Front Emblem

Bulletin Type:	TSB	Publication Date:	March 2026
Bulletin #(s):	26-006	Make(s):	Entegra Coach
Job Code(s):	9803648	Model(s):	Centurion
Flat Rate(s):	9803648 – .75 HR – Front Emblem Securement	Model Year(s):	2026

FRONT EMBLEM REPLACEMENT INSTRUCTIONS

Technical Service Bulletin Notification TSB #: 26-006

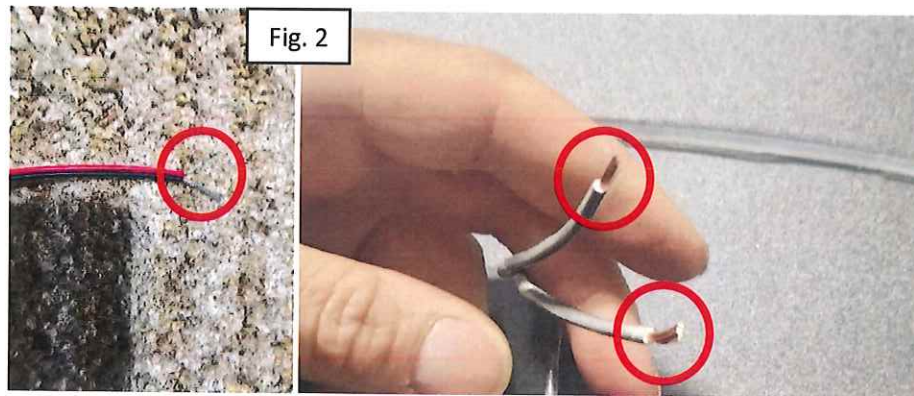
4. Strip the wires coming from the coach using wire strippers.

- a. **Note: the below images are for reference and are not from the repair. They are only for reference on stripping the wire.** (Figure 2)

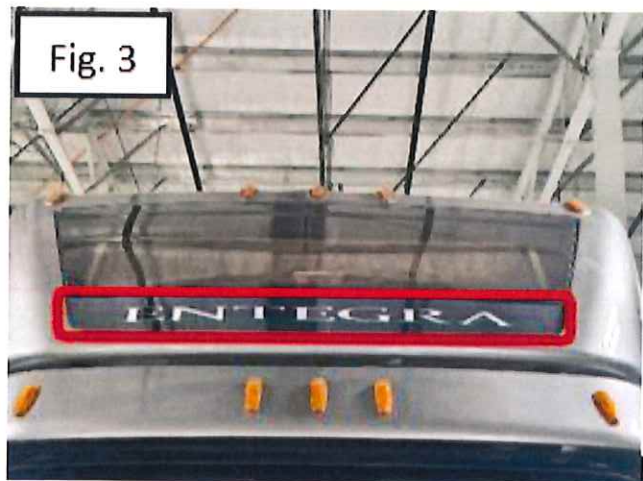
8. Resecure the new emblem to the front of the coach using Plexus and Sika. The Plexus should be run in 2 beads down the sides of the emblem and 3 or 4 evenly spaced dabs on the top and bottom of the emblem. Sika will be used in between each of the dabs of Plexus on the top and bottom of the emblem. (Figure 3)
